# Triumph T120 Fork Changes During 1968 & 1969 Model Years

## SERVICE BULLETIN

69/13

### 1969 TRIUMPH FRONT FORK - DIMENSIONAL CHANGE - STANCHION CENTRES

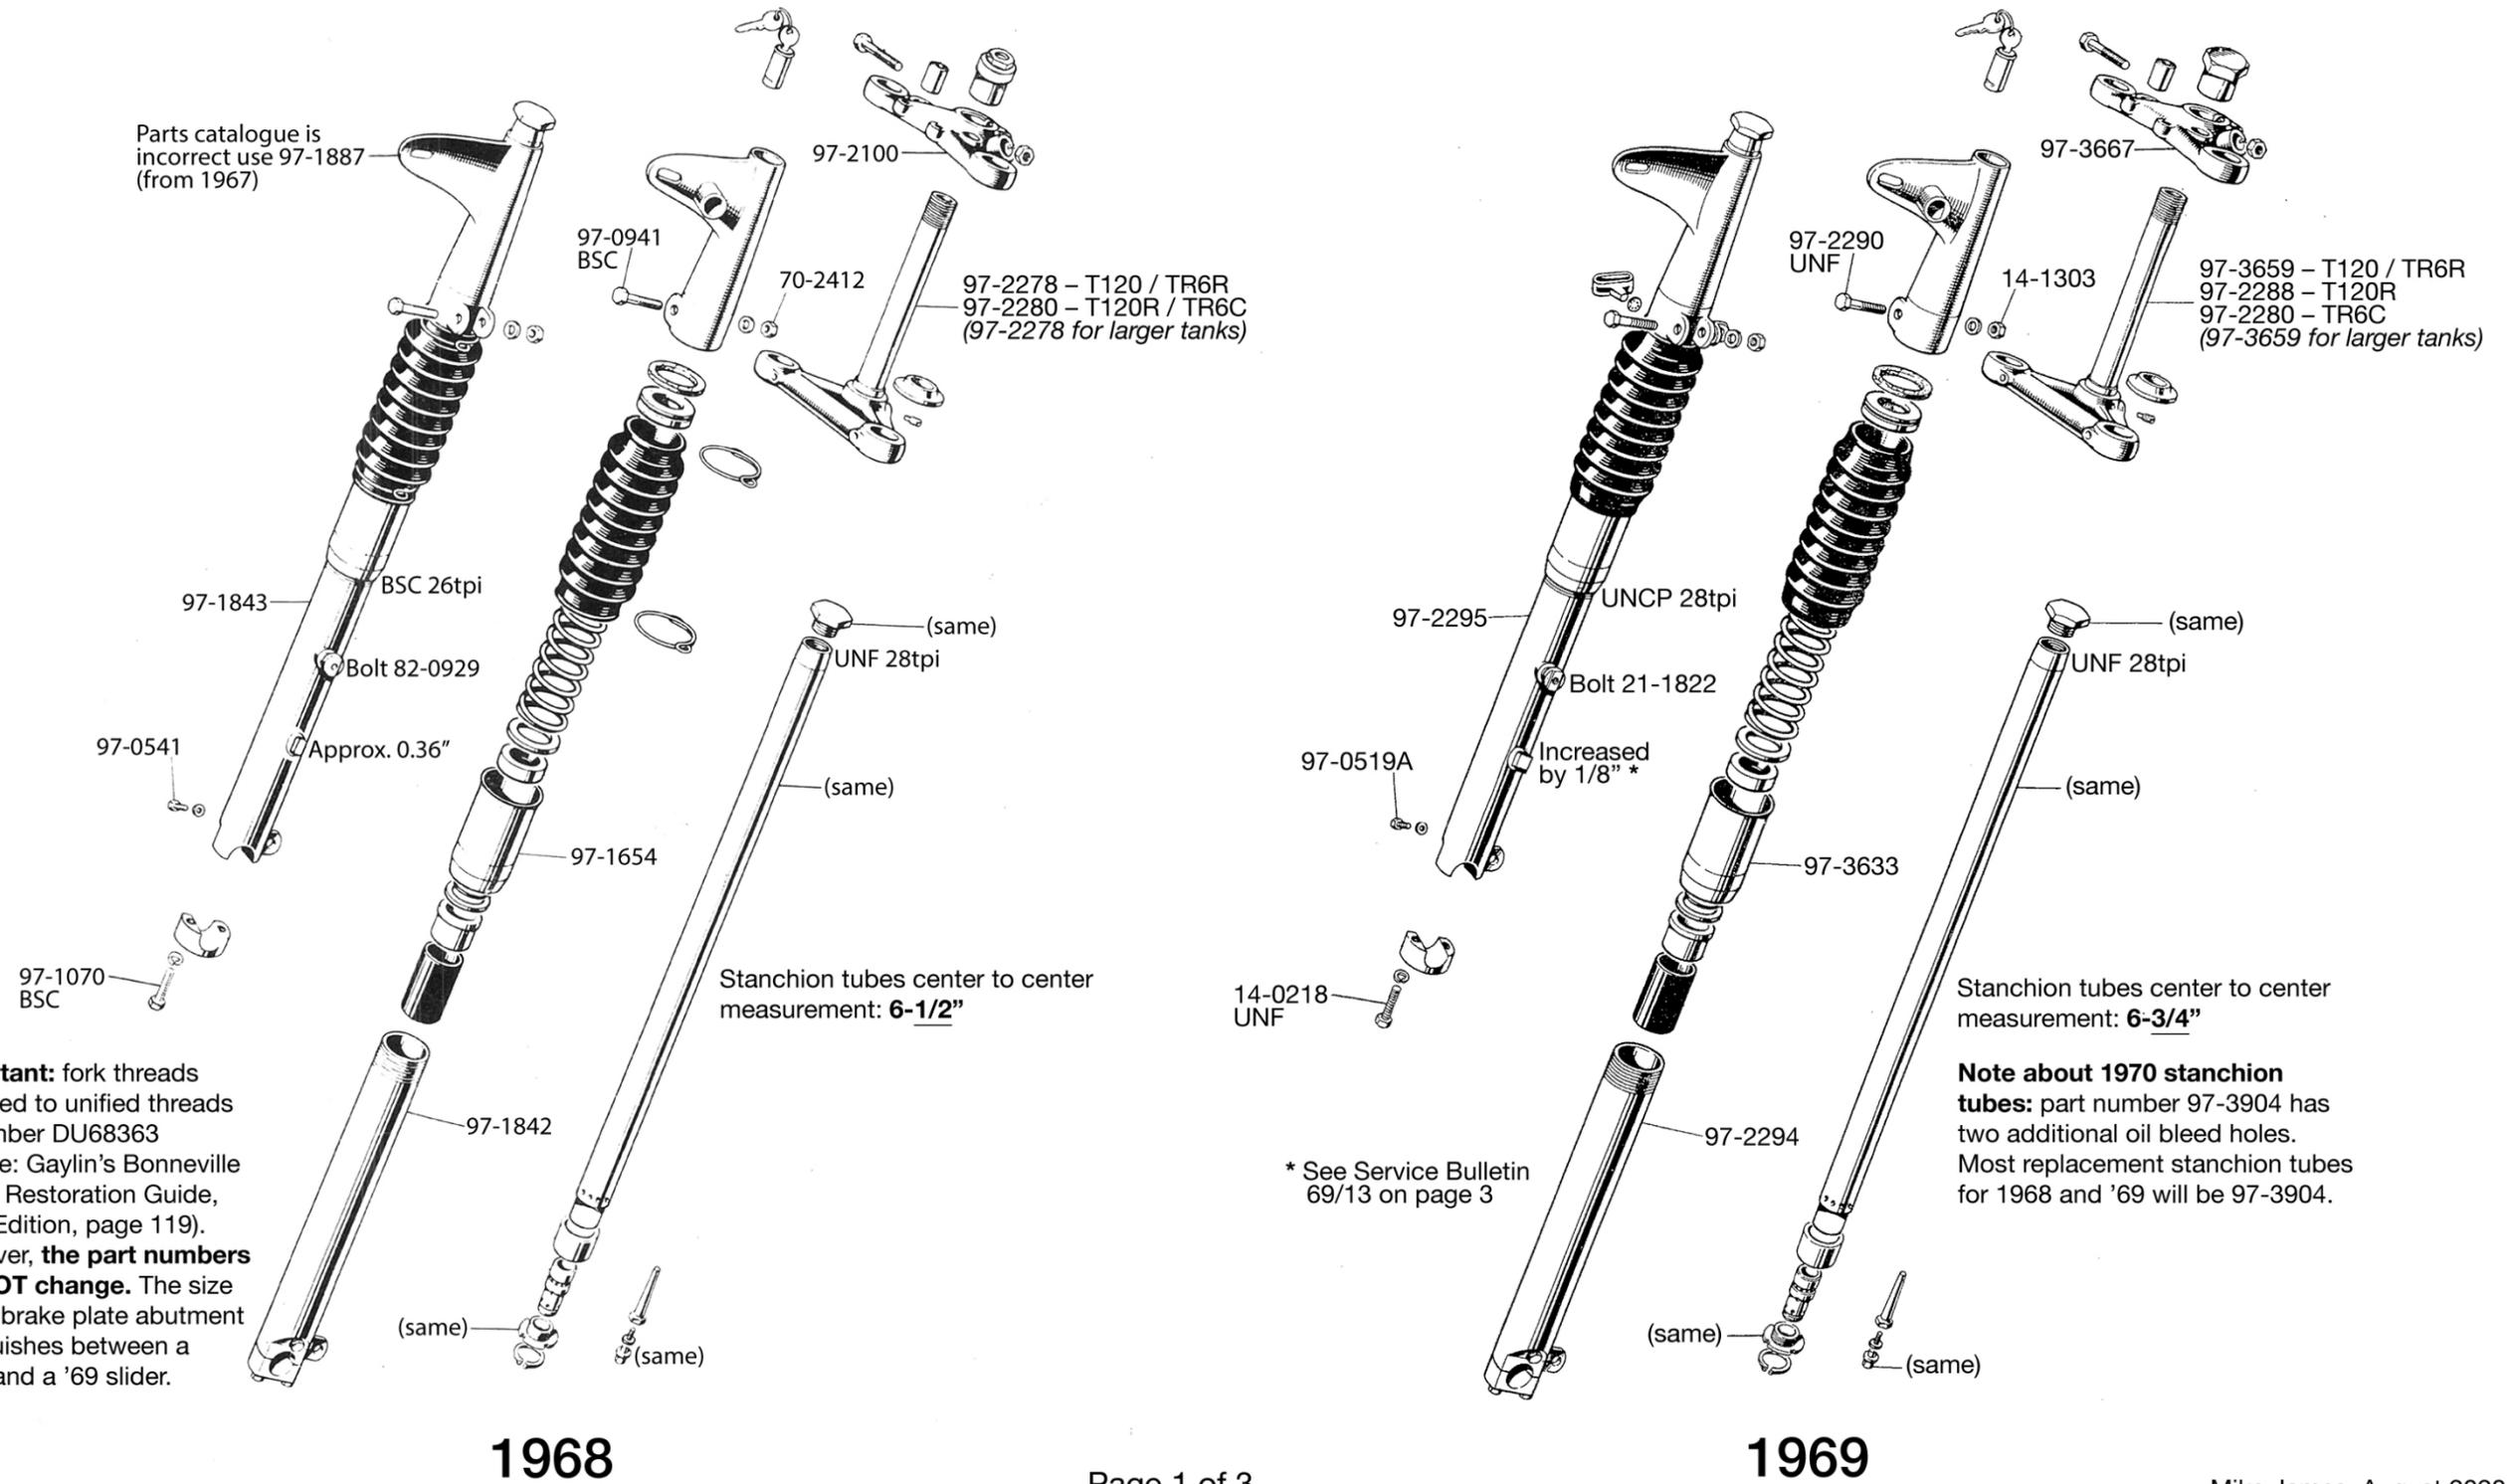
Increasing the width of the forks for the 1969 model year was an adjustment likely associated with the changes to the brake plate that began with the introduction of the twin leading shoe (TLS) front brake for the 1968 models. (Some 1967 models were retrofitted by the dealers with factory supplied upgrade kits.) The brake plate was changed again for 1969 to reroute and reduce the length of the brake cable. Whatever the actual reason for the increased fork width, **the center to center measurement of the stanchion tubes increased by 1/4"** from 6-1/2" in 1968 to 6-3/4" for 1969 models.

When the width between the stanchion tubes increased, this made it necessary to **increase the size of the brake plate abutment** on the inside right bottom member (slider). The abutment increased approximately 1/8" from the slider toward the brake plate.

Given that some later 1968 sliders required unified thread hardware it is important to measure the brake plate abutment on the right slider to determine whether the slider is for a 1968 or a '69 fork. Using a 1968 slider on a 1969 fork will mean there is very little (possibly too little) abutment securing the brake plate.

## Triumph T120 Axles for 1968, 1969 & 1970 Model Years

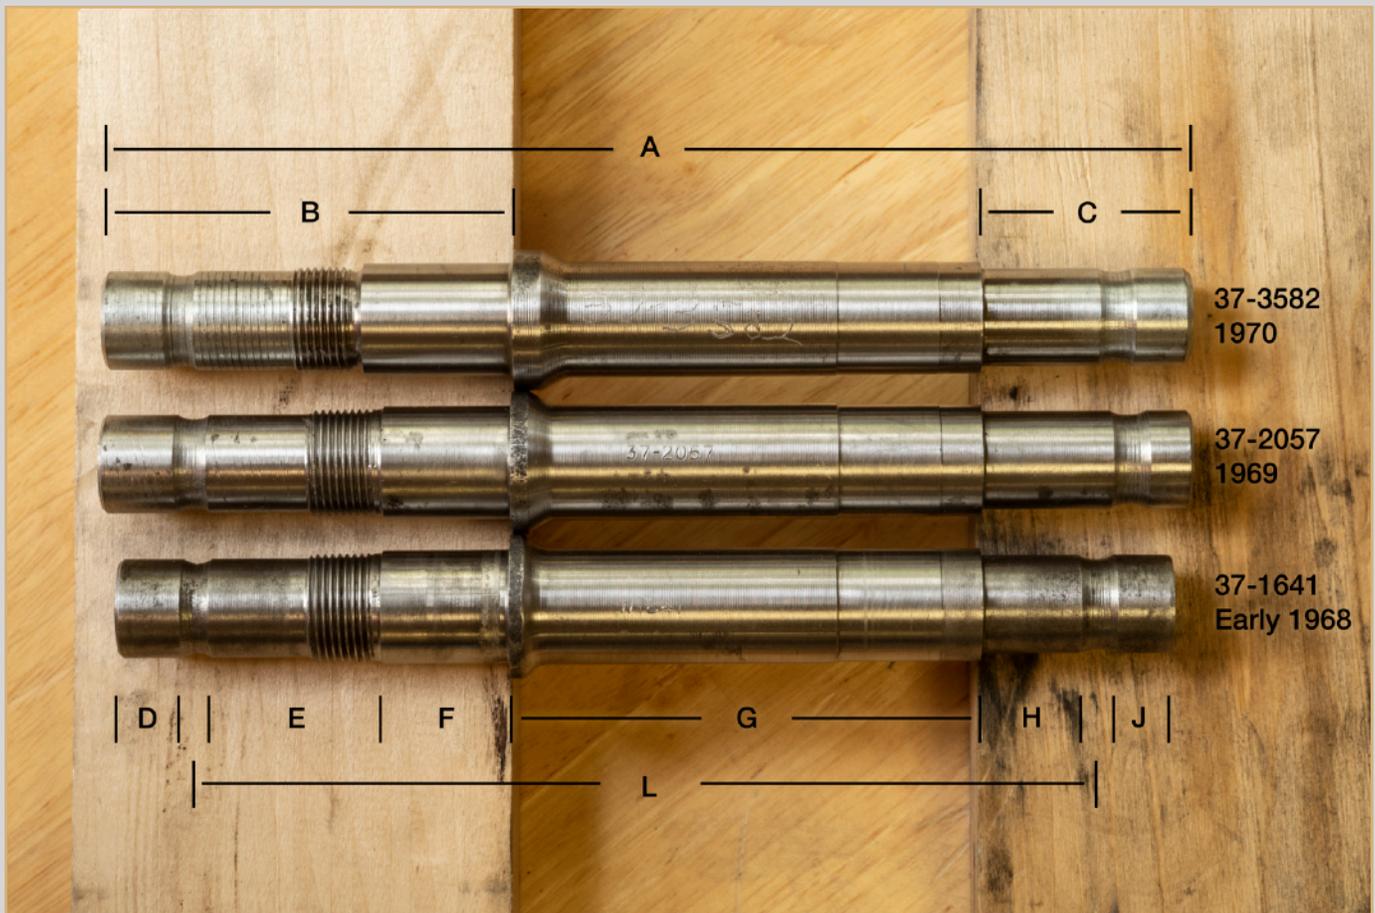
37-1641	37-2057	37-3582
<u>Lengths</u>	<u>Early 1968</u>	<u>1969</u>	<u>1970</u>
A	7.25"	7.50"	7.50"
B	2.68"	2.81"	2.81"
C	1.30"	1.42"	1.42"
D	.44"	.52"	.41"
E	1.18"	1.22"	1.15"
F	.88"	.88"	1.04"
G	3.25"	3.25"	3.25"
H	.66"	.89"	.81"
J	.40"	.30"	.40"
L	6.20"	6.47"	6.47"

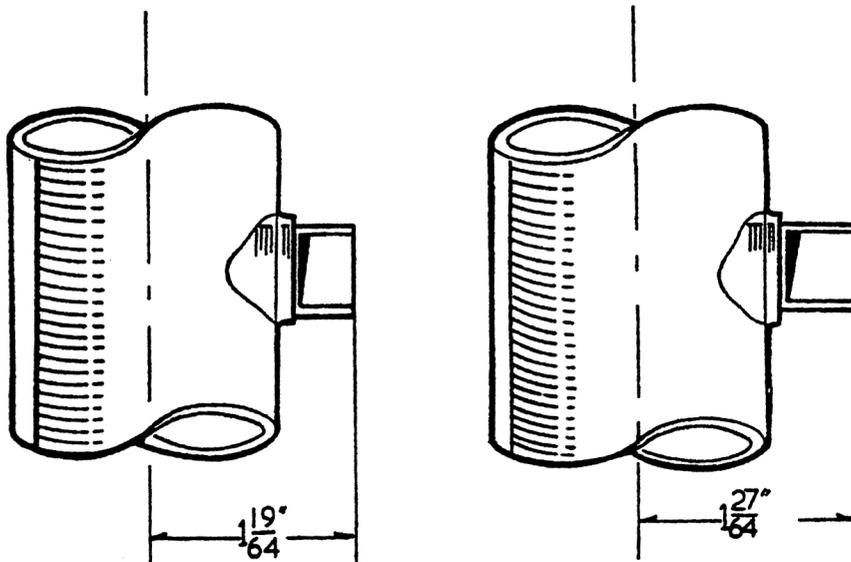
Front brake anchor peg (see sketch) for 1969 models is 1/8" longer than preceding models, requiring a new part number for R.H. Lower Member.

NT - 1/4" length of engagement must be maintained between anchor peg and brake plate. If an earlier R.H. Lower Member were used for a 1969 model, insufficient engagement would result.

H1843 (1968)  
R. H. Lower Member

H2295 (1969)  
R. H. Lower Member
